**Draft Solar Ponds Plume
Decision Document Modification
April 29, 2002**

This document is a minor modification to the Solar Ponds Plume Decision Document (DOE 1999) addressed the remediation of the Solar Ponds Plume (SPP). After the installation of the remediation system was completed in 1999, it was apparent that the treatment system was functioning properly, but that not all of the captured groundwater was getting to the treatment cell. The objective of this modification is to increase the amount of water treated by the treatment system by installing a collection sump in the existing collection trench and pumping groundwater into the existing treatment cell.

Figure 2
Conceptual Drawing of Collection Sump and Solar-Powered Pump

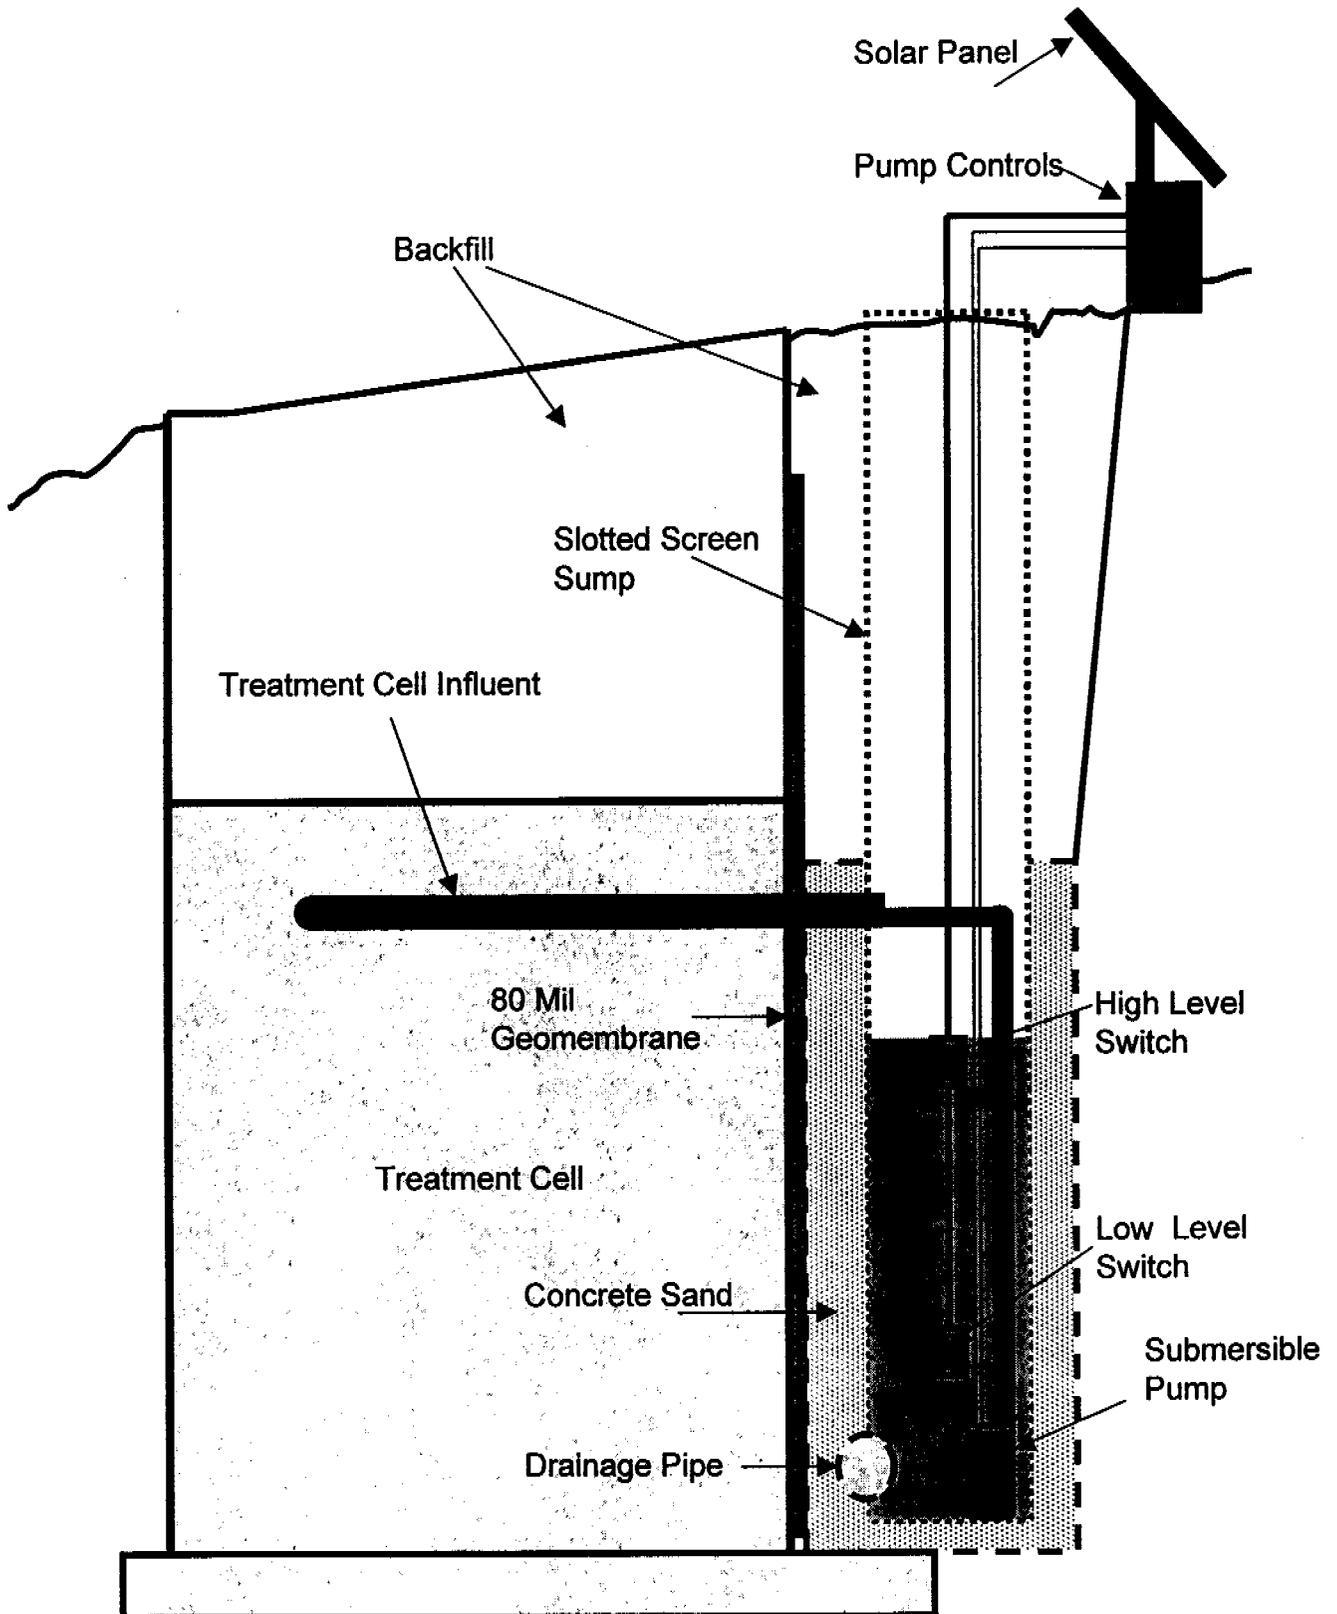
A solar-powered submersible pump will be placed in the sump as shown in Figure 2. The pump discharge line will be constructed of flexible tubing, which will be fed down the treatment cell influent line. The end of the existing treatment cell influent line will be left open in the trench so that, if groundwater rises to the influent line, groundwater can still also gravity flow into the treatment system. The pump will have a maximum capacity of about 5 gallons per minute to keep the pump from cycling on and off. The pump control system will consist of a low level and high level switch, which will maintain the water level in the sump between 20 and 25 feet deep (5 to 10 feet below the existing influent line).
